**CITY OF CLEARWATER
PLANNING & ZONING**

**PUBLIC HEARING AGENDA
JANUARY 7TH, 2020**

7:05 COMMITTEE DISCUSSION ON APPLICATIONS SUBMITTED
FOR THE PROPOSAL OF A 52 UNIT APARTMENT BUILDING.
PUBLIC HEARING WAS HELD ON NOVEMBER 26TH, 2019.

Date: November 19, 2019
To: Honorable Mayor Lawrence-Wheeler, Members of the City Council and
Members of the Planning Commission – Clearwater, Minnesota
From: Justin L. Kannas, P.E.
City Engineer
Subject: Clearwater Estates Apartments
Clearwater, Minnesota
BMI Project No: W13.118405

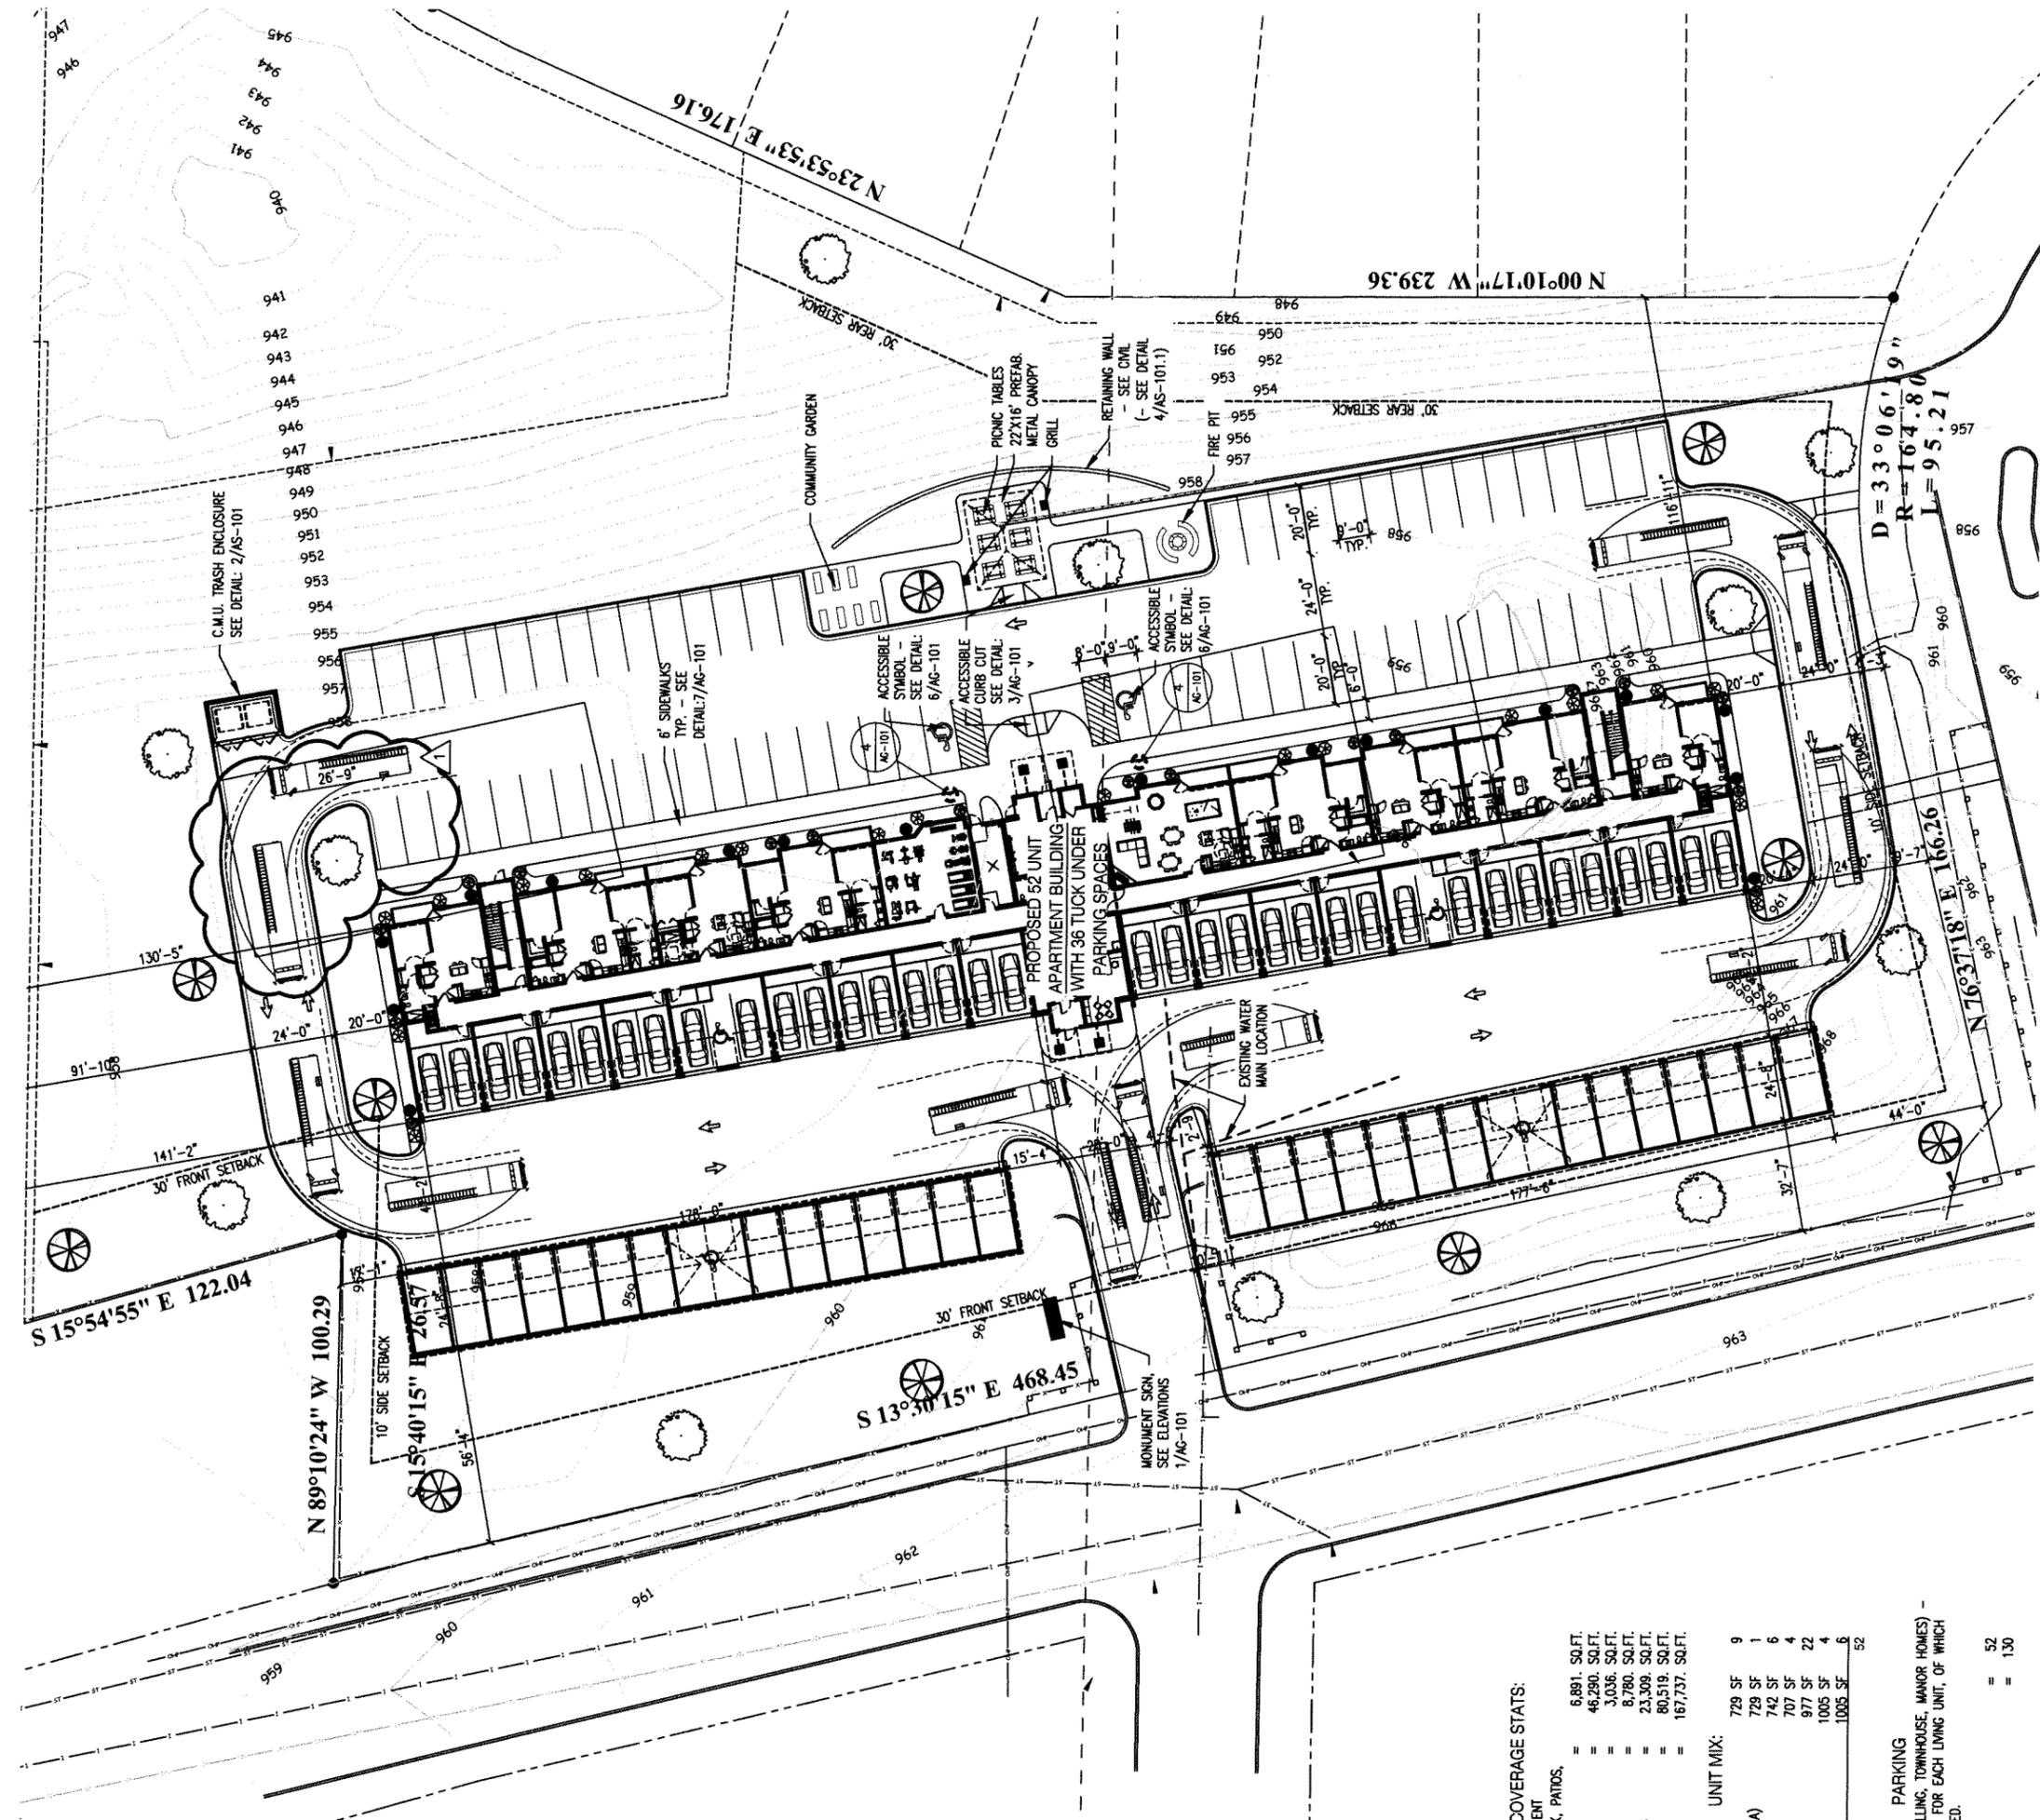
I don't have any issues with the overall height of the building. The Fire Department would not need to buy any special equipment based on the height of the building. I have a question on the width of the access road around the apartment building. Our Engine 11 is very long and if the access road around the building is too narrow we would have an issue getting to the back of the building.

Here is a site plan with the Fire Dept dimensions/turning radius for a Ladder Truck (same as the Fire Chief gave us).

The truck clears, with ease, all drives around the perimeter of the building, as currently designed.
